**RE: Council response to OEH submission**

**Modification to concept plan approval  
Kirrawee Brick Pit Mixed-Use Development  
566-594 Princes Highway, Kirrawee (MP10\_0076 MOD 8)**

### Response to issues raised in OEH submission to the MOD 8 Application for the modification of the Park at the Kirrawee Brickpit Site.

POSSIBLE AREAS OF  
ADDITIONAL STIF  
SSC MARK UP 03/05/2018

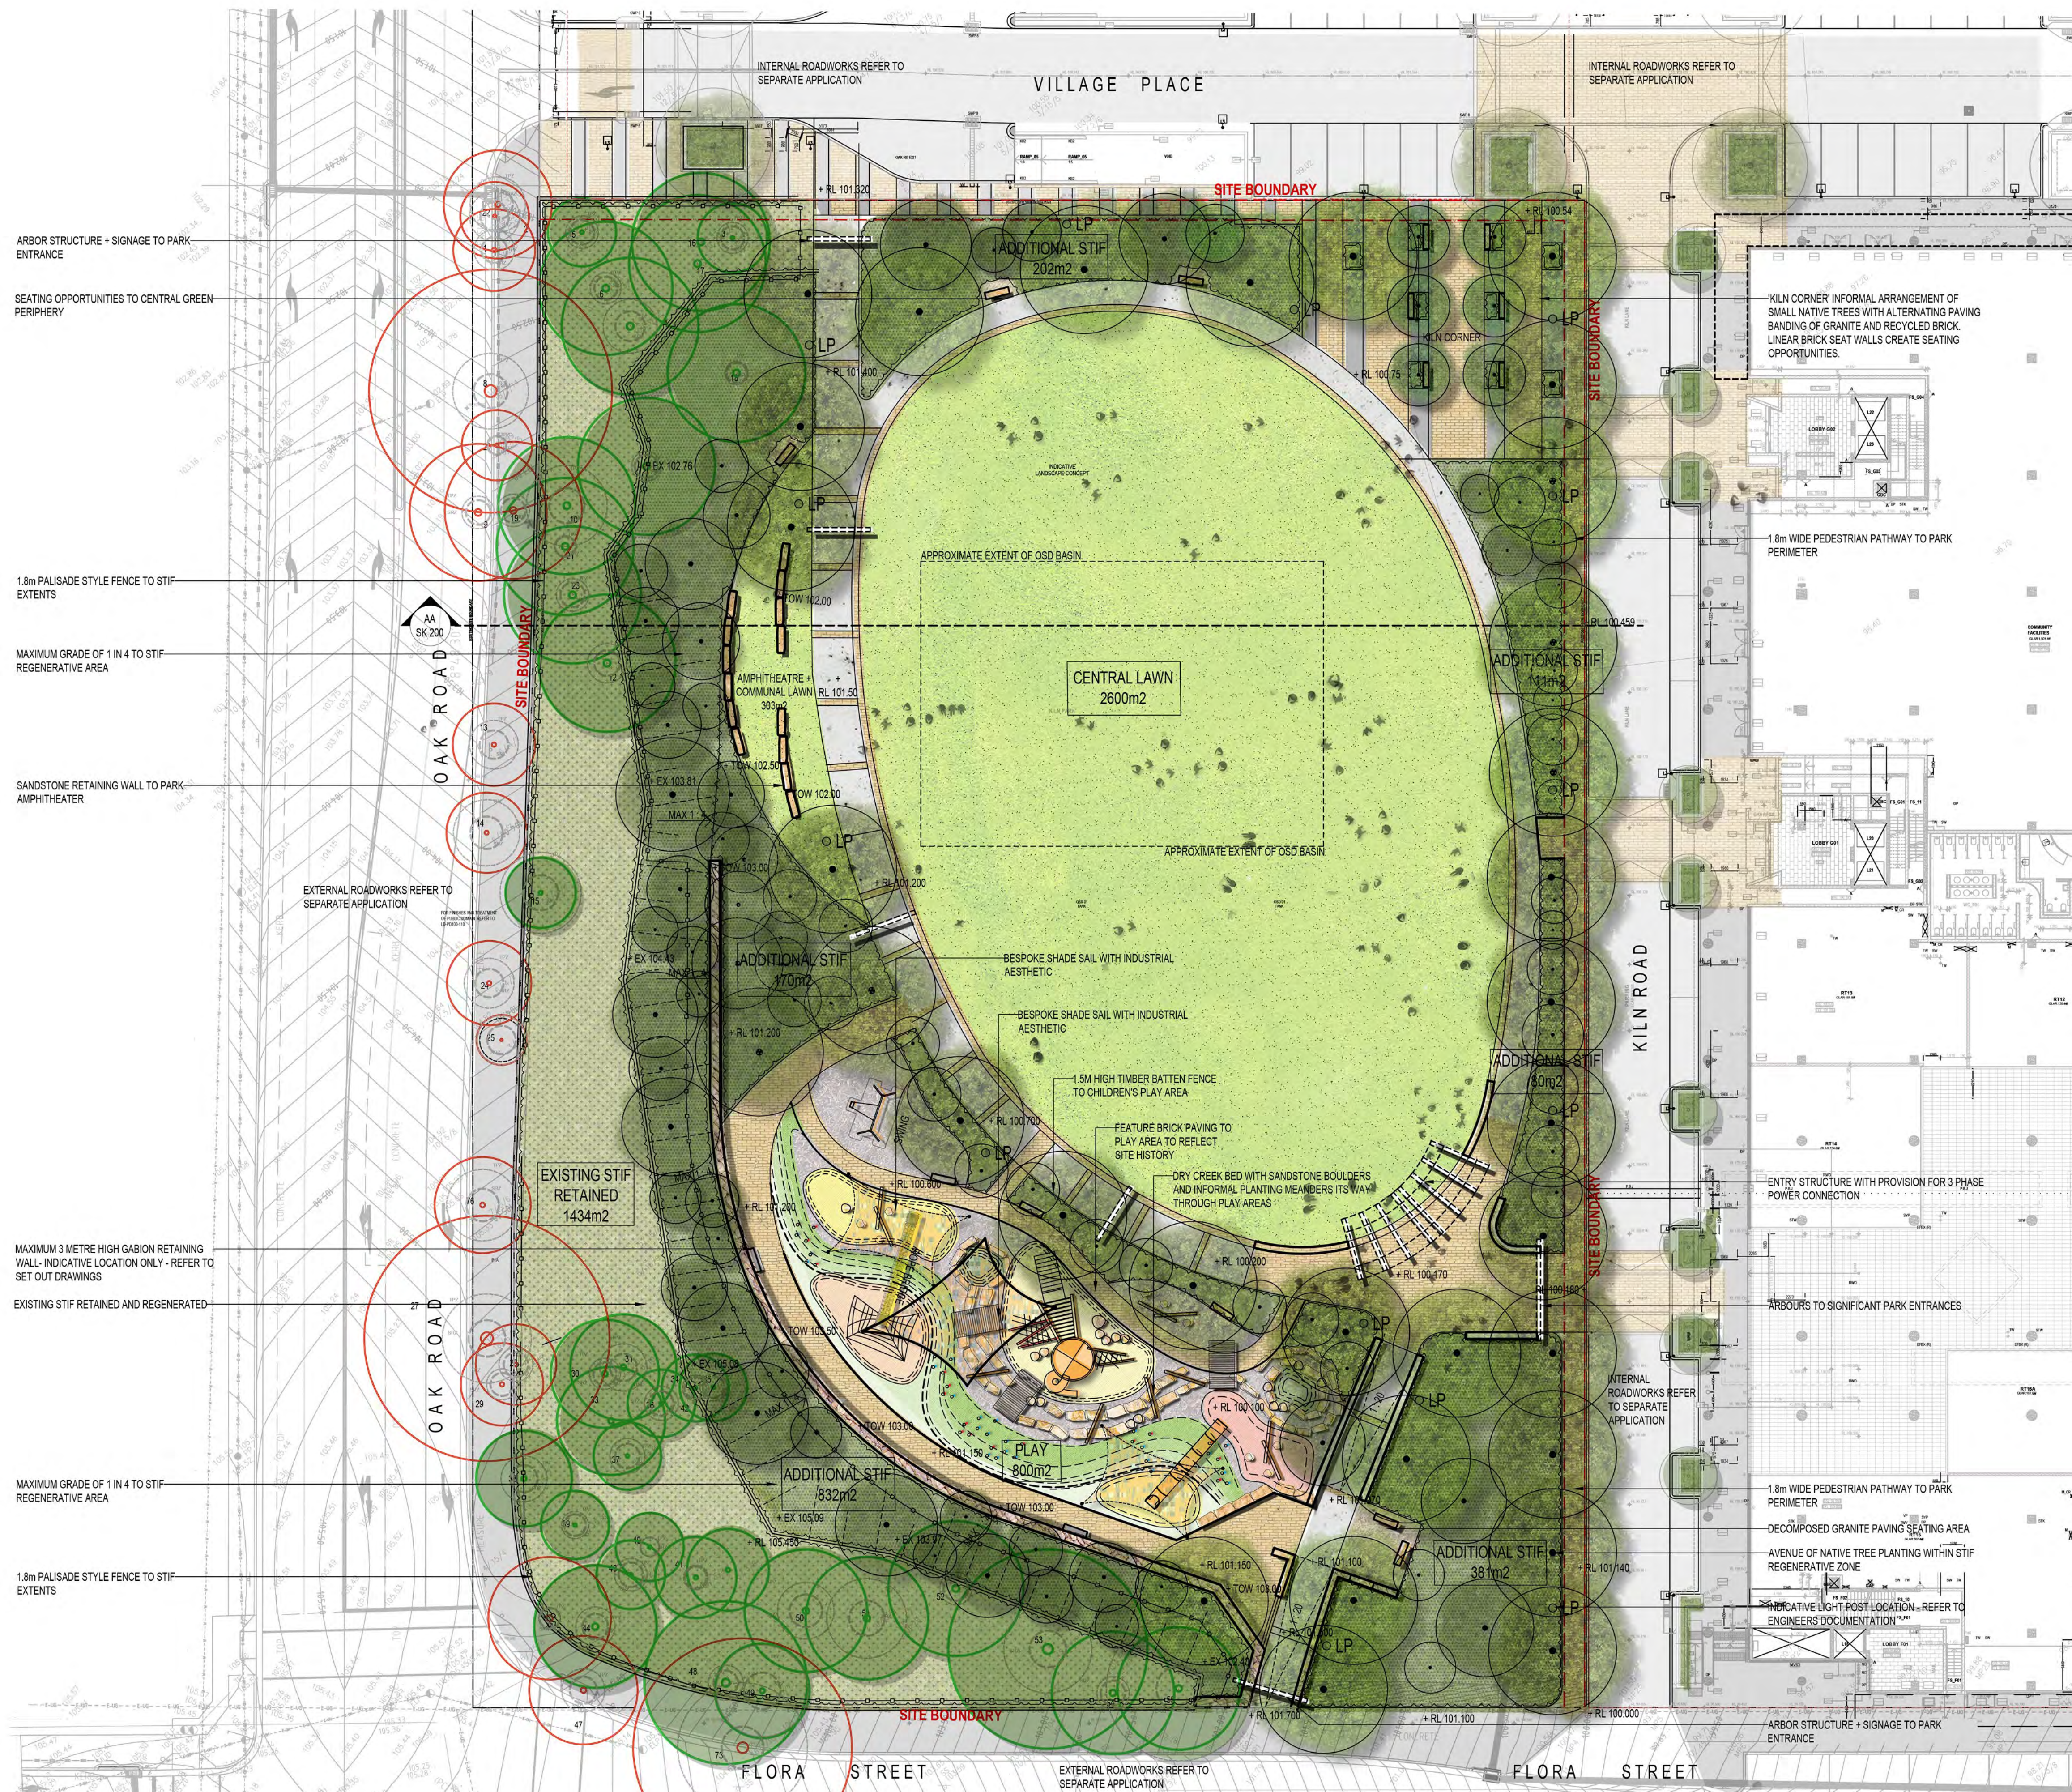
**OEH comment 1 May : It is noted the additional STIF planting (Areas A, B C, D and E) which provide for 944m<sup>2</sup> of regenerated STIF, that only Area A adjoins the STIF regenerating on quarry walls (832 m<sup>2</sup>) and that Areas C and D are located on the eastern side of the central lawn area. Is there potential for Areas C and D to be relocated so they adjoin or are in closer proximity to the STIF regenerating on quarry walls (832 m<sup>2</sup>)?**

the eastern boundary of the park to soften the park edge. While Areas C and D have an aesthetic value, as noted in Council's response above, the location of Areas C and D are sub-optimal from a conservation perspective (ie remote from the main area of STIF and they are long and thin having a high perimeter to area ratio). OEH queries whether these areas should be used as part of the offset area and whether an equivalent area of 111m<sup>2</sup> and 80m<sup>2</sup> for Areas C and D should be provided as part of the offset closer to the main area of retained STIF.

**OEH comment 1 May : The sketch of the additional 800 m<sup>2</sup> of STIF planting (Areas 1, 2, 3 and 4) shows Areas 3 and 4 is contiguous with the STIF regenerating on quarry walls (832 m<sup>2</sup>) which is supported. The Sketch shows Area 1 is located in close proximity but it is unclear what the linear feature is that is located along the western boundary of the lawn area. Is there potential for the linear feature to be re-located? Is there potential for Area 2 to be relocated so it adjoins Area 1?**

**The RTS needs to include a scaled plan which shows the 800m<sup>2</sup> can be accommodated on the site and preferably so it adjoins the remnant STIF**

Seeking to address OEH's concern, Council provided a revised plan (dated 20/04/2018) followed by a further revised plan titled, Possible areas of additional STIF and dated 03/05/2018 (Attachment 4). OEH supports this latest plan which shows the possible location of 800m<sup>2</sup> of additional STIF. This plan also shows the opportunity to retain a further 115m<sup>2</sup> of existing STIF on original soils by removing the boardwalk area in the south-western part of the park.

Council has provided a plan which shows possible locations for 800m<sup>2</sup> of additional STIF planting within the park (Attachment 4). The plan shows additional STIF located in areas adjoining the remnant STIF on the western part of the park. Final locations of additional STIF are subject to detail design. OEH supports this plan.

Reconsideration of the location of the additional STIF has resulted in a revised layout that provides for the majority of the additional 800m2 of STIF to be located immediately adjacent to existing STIF on original soils and that regenerating on quarry walls. This is considered a superior outcome to that originally proposed, as it locates the majority of the compensatory STIF on the western portion of the site, providing for an effectively larger contiguous area with a reduced perimeter area ratio. A scaled plan is provided as requested to demonstrate this (see Figure 5.)
